Access Compliance Report

Public Rights-of-Way

Intersection ID: 11974	Main Street: N_BREVARD_ST	Cross Street: E_11TH_ST	Location: N
ADA ID: 973E74BBB3D6	Ramp Type: Perp	Initial Pass/Fail: Pass	Overall Compliance: No
			Severity Score: 22.5

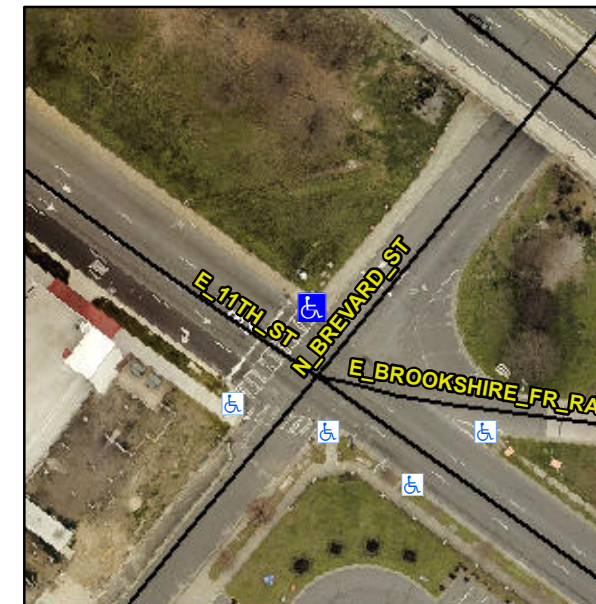
**R304.2.2-Perp, R304.3.2-Para,
R305.1.4, R305.2, R302.7, R302.7.2,
R304.5.4**

**Remove & Replace Entire Ramp.
Remove & Replace Gutter.**
